**RE: ESTUARINE MANAGEMENT STUDY: PROPOSED MIXED USE SUBDIVISION - WEST CULBURRA, NSW. PEER REVIEW.**

The report reviewed by BMT WBM is entitled *Estuarine Management Study: Proposed Mixed Use Subdivision – West Culburra, NSW (P1203365JR02V03 August 2014)*.

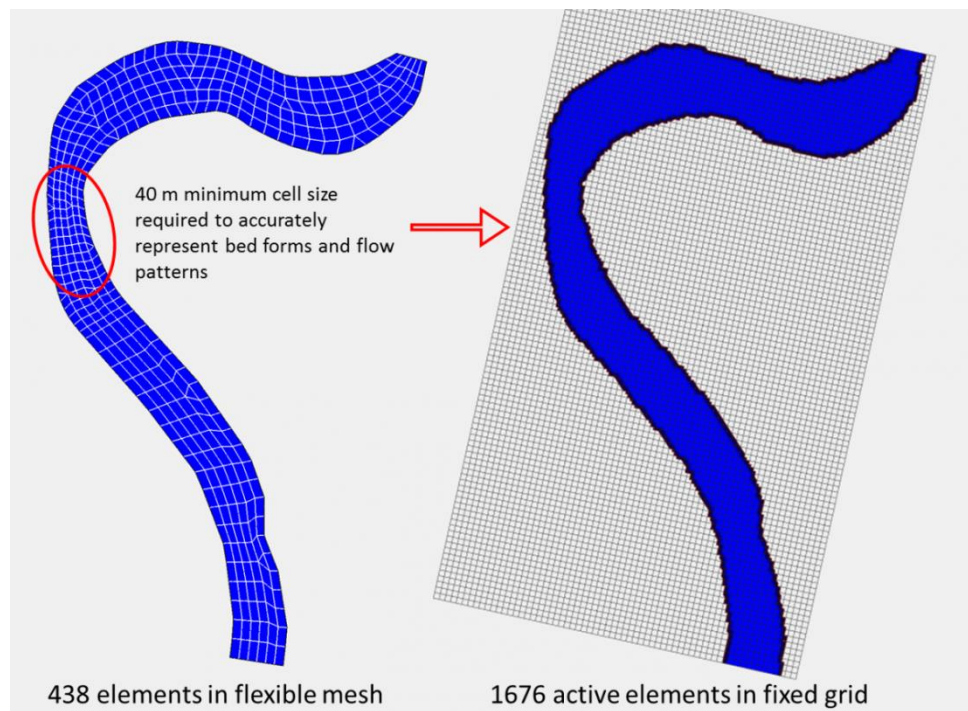
In the case of this study however, the choice of a 50m cell size should not have been considered in any case, regardless of computational overhead issues. This is because the key bathymetric features of the river that control the exchange of tidal waters are of a similar scale to the cell size, and thus resolving them appropriately is difficult (or impossible) in such a coarsely defined model. For example, there is a hydraulic constriction near Billy's Island that includes a deep channel with fringing shallows (including oyster leases). The width of this channel is 50 metres, as shown below (the distance between the pair of white dots spanning the channel is shown in the left panel).

It is unacceptable to have a model attempt to resolve such a critical flow channel with only one cell. It would normally be expected that such a key channel would be resolved by at least 3 cells, and more likely 4 to 6 cells. Without this resolution, it is unlikely that a model such as that reported here would be able to resolve and capture the required hydrodynamic exchange processes through this (and other) section that are critical to a study that is investigating pollutant advection and dispersion. Issues that might arise from this inappropriate assignment of cell size include:

- Potentially large overestimates of bed friction due to numerical drag
- Artificial retardation and constraint of tidal flows
- Appearance of 'steps' in the model bathymetry that are not realistic, but are a result of the model's inability to resolve natural flow paths. These steps block flow.

Notwithstanding this however, it is BMT WBM's view that a 50m cell size is too coarse for this application and either (a) a much finer grid size should have been adopted, or even better, (b) a model appropriate to the hydrodynamic setting should have been used. Such a model would use a flexible computational mesh rather than the fixed grid mesh model adopted here. The image below presents a comparison of how differently the flexible (left) and fixed (right) grid model meshes behave in sinuous settings. The flexible mesh easily and smoothly resolves the sinuous channel and uses fewer computational elements than a similarly sized fixed grid model. The flexible mesh model also has no jagged edges on the river banks, whilst the fixed grid model does have rough edges that have the potential to create numerical drag issues in a tidal environment, as discussed above.

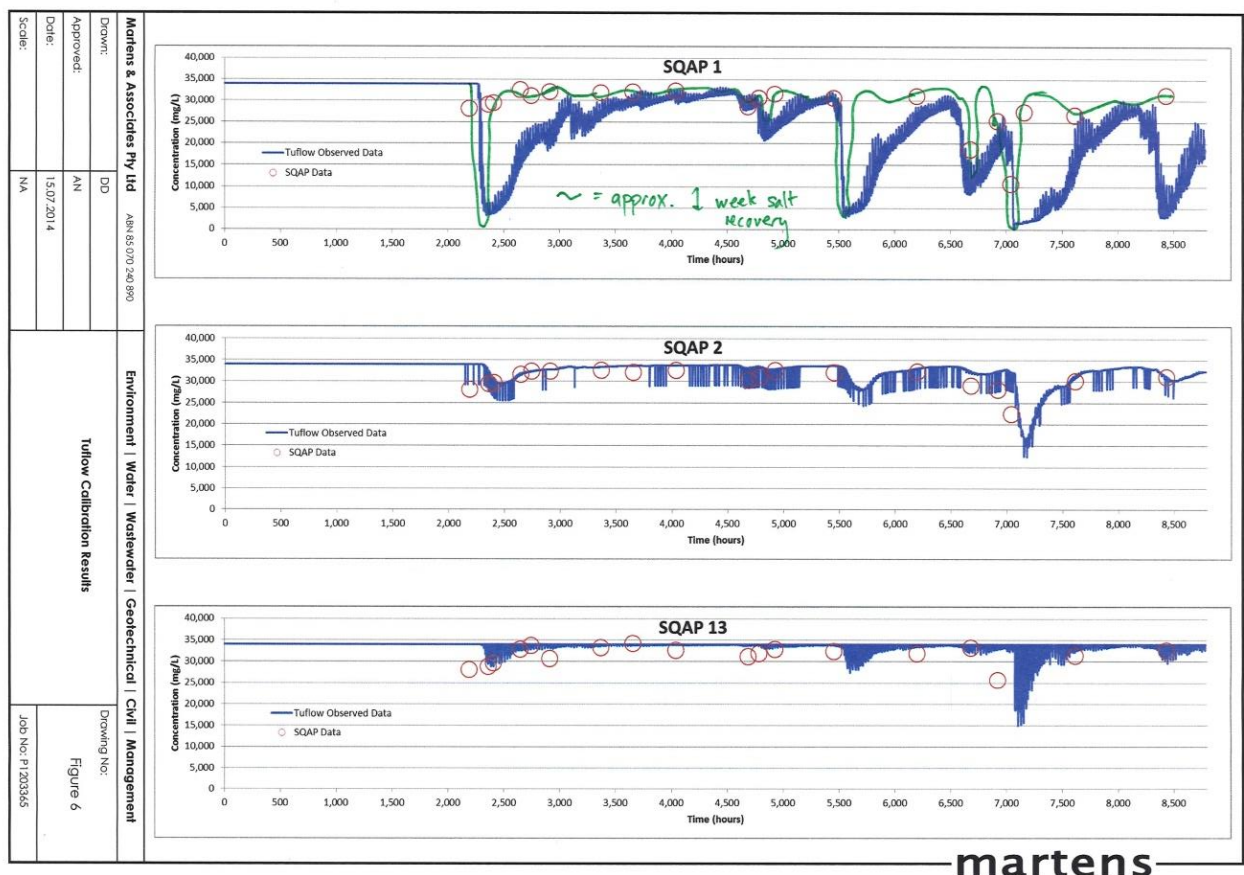
The assessment of the calibration performance presented in section 3.3.3 of the report is also noted, where, for example, the model performance at site SQAP 1 was described as 'seems to be slightly underestimated overall ... the calibration in this area is acceptable' (page 19 section 3.3.3 bullet 3). BMT WBM disagrees with this assessment. In particular, it is our view that the model is not capturing advective processes responsible for salt (and therefore pollutant) transport within the system. Our reasons for taking this view are described below.

As noted above, model performance at site SQAP 1 is described in the report as 'slightly underestimated overall', and yet the model does not capture the salt recovery associated with the first inflow event at approximately 2500 hours. Rather, the model predicts a salt recovery time of approximately 1000 hours (acknowledging that there are some smaller inflow events over this period that will marginally retard salt recovery), which is approximately 40 days. This is a very long recovery time, especially given that (a) the monitoring data shows almost immediate salt recovery at SQAP 1 (even within the 7 day sampling error bounds noted in the report) and (b) the distance from site SQAP 1 to the open ocean is only a matter of a six or seven kilometres – salt recovery over this short distance is very unlikely to take 40 days in an area where spring tidal ranges are almost 2 metres. Recovery over 40 day seems implausible, and isn't supported by measured data.

A more plausible salt recovery time over this short distance to SQAP 1, in the opinion of BMT WBM, more like several days following inflow cessation, up to a maximum of perhaps a week (approximately 160 hours). This timeframe is consistent with all measured data, and much shorter than that predicted by the model.

Below is a hand drawn alternative for a model prediction that BMT WBM would expect to be more likely in this small estuary. Clearly this hand drawn prediction is qualitative only and is not meant to indicate anything other than a possible alternative to the predictions presented, with this alternative being consistent with a 7 day (maximum) recovery time and salinity measurements at SQAP 1.

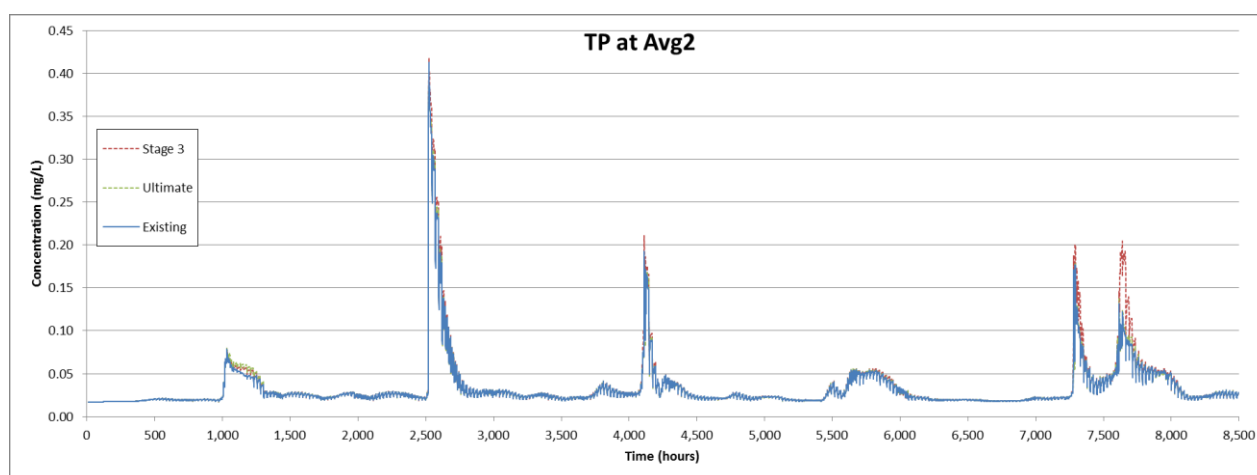
The report presents base case results that demonstrate this 'swamping' of the river by upstream flows. One timeseries (TP) of model outputs is presented below from the report. The spikes at hours 1000, 2500, 4100, 5500 and 7300 show very large base case (blue line) spikes in TP. This means that the upstream catchment is dominating the pollutants delivered to the river. It is only the last event at 7600 hours where some differences are noticeable between base case and scenarios.

Given this, one could not reasonably expect to see any significant modelled impacts from the developed 109 ha site, and the above figure supports this view. Perhaps it is not surprising then, that the report predicts minor impacts of the development (page 23 section 3.5.2 bullet 2ai 'The vast majority of results show that changes to salinity, TN, TP and TSS at all points are negligible').

One suggestion for a more representative scenario is where upstream inflows are minor, but local rainfall generates runoff from the proposed development and its surrounds. This may well be a 'dry' year/period

from a whole of catchment perspective, but one that still includes several rainfall events over the site of interest, such as local storm cell type events or similar. Without this style of scenario arrangement, nothing meaningful can be expected from the scenario assessments presented in the report. Given this, and noting that (a) the hydrodynamic modelling is flawed and (b) the AD model is poorly calibrated and does not capture salt recovery behaviour, no further effort has been made in this review to consider the scenario assessments beyond the above.
